Response to key stakeholder submissions

B1 NSW Health

Figure B1-1 Domain and buildings for Rozelle sensitivity tests

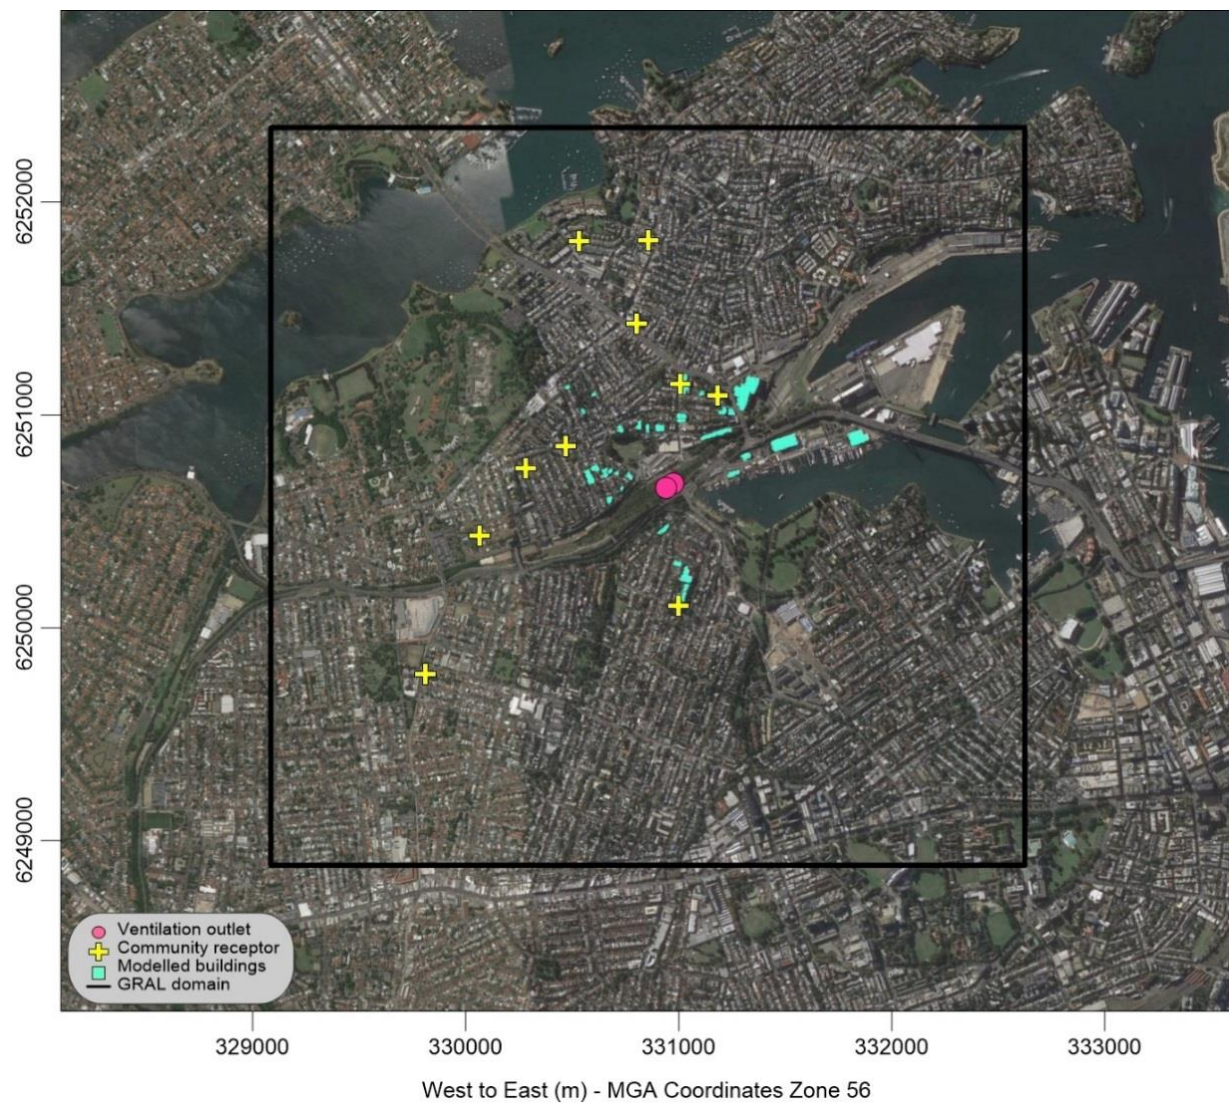
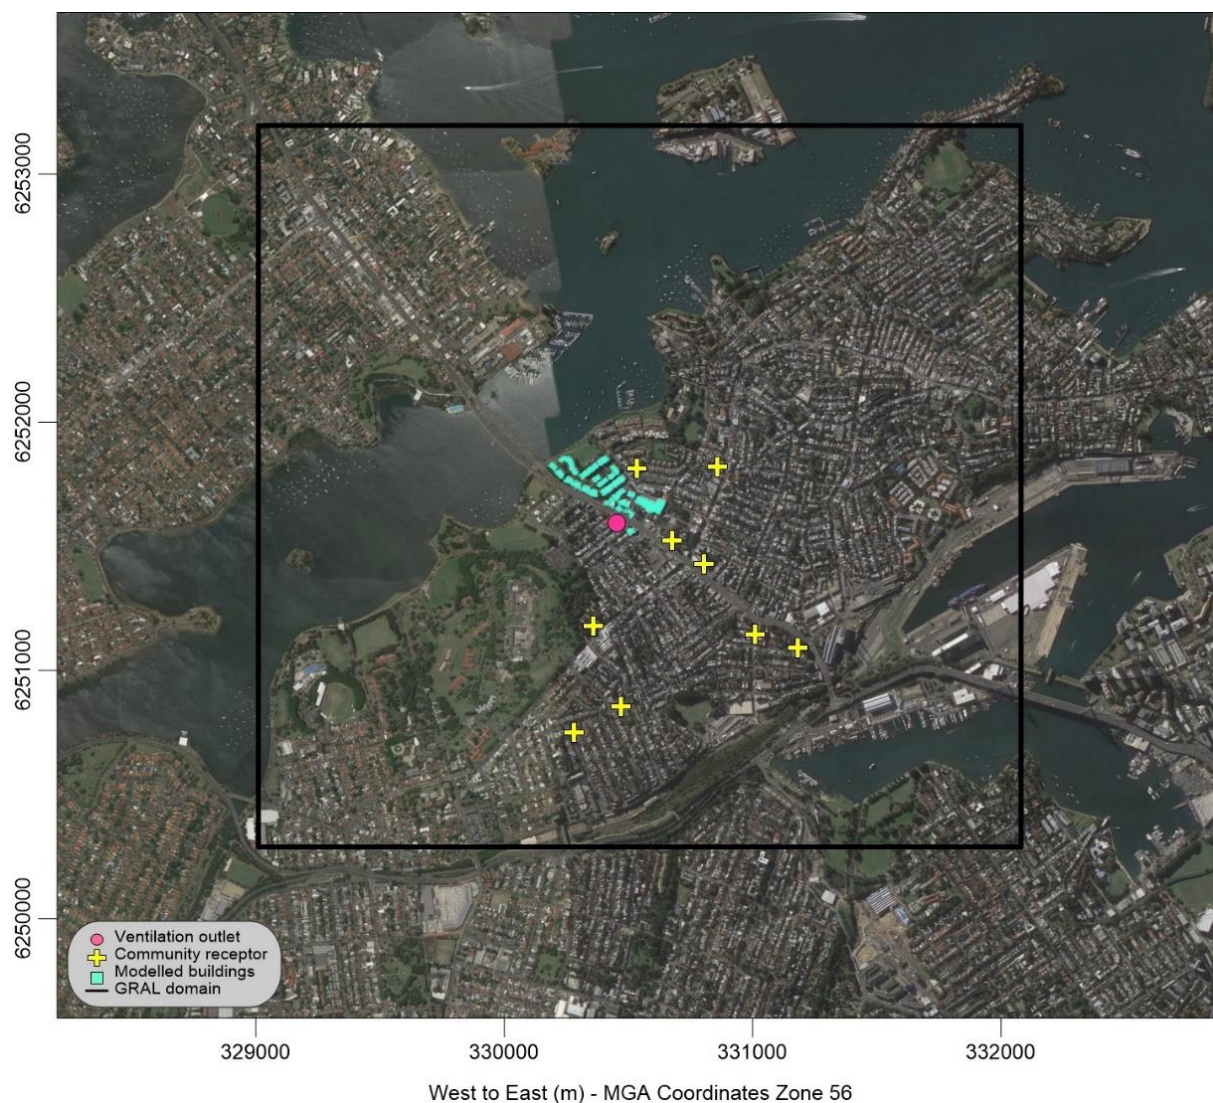
Buildings can be included in dispersion modelling to account for building wake effects in the vicinity of ventilation outlets. However for the project assessment, buildings were excluded (the rationale for this was provided in section 8.4.6 of Appendix I of the EIS). The sensitivity of the inclusion of buildings to predicted concentrations was therefore assessed in response to NSW Health's submission on the EIS. As noted earlier, the effects of buildings were tested for both the Rozelle and Iron Cove Link domains. The buildings included in the tests are shown by light blue shading in **Figure B1-1** and **Figure B1-2**.

The results for the Rozelle domain are given in **Table B1-4**. These show that although there were increases in the concentrations associated with the ventilation outlets due to the inclusion of buildings in the sensitivity tests, the outlet contributions remained very small relative to the criteria.

Although there are localised increases at some receptors with buildings included, the largest increases for a receptor with buildings included is 64 times less than the criterion for 24-hour $PM_{2.5}$ and 155 times less than the criterion for annual mean $PM_{2.5}$. The total predicted concentrations, and the conclusions of the assessment, would not change significantly with the inclusion of buildings.
